Roland Corporation

RE : CHANGE PICK-UP FOR GR GUITARS

CHANGE

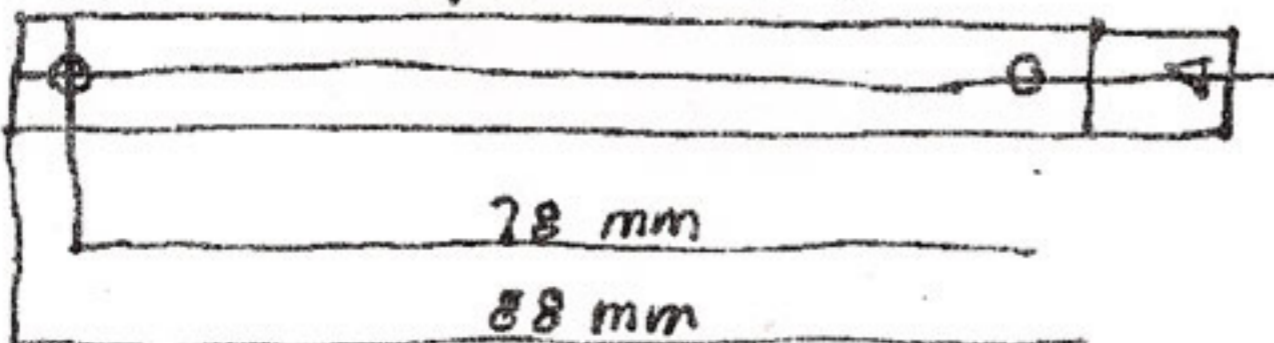
We inform you that we have changed the pick-up type and can't get the old one (#601) anymore.

Old type : #601 pick-up 22380601
New type : #610 pick-up 22385610

When you meet aboves, please order new type pick-up and change resistor value as follows.

1. change resistor value (for feedback) on the PREAMP Board.

* G-303, G-505, G-808 (See fig 1)
R19 : 1M → 100K
R12 : 330K → 33K

* G-202 (See fig 2)
R8 : 330K → 33K

Note) Take above modification to all channel (1-6), referring to our Service Notes

2. Fig. 3 (for only G-202/G-505)

601 / A = 10mm
610 / A = 12mm

shave about 2mm to guitar body and pick guard which is fitted the
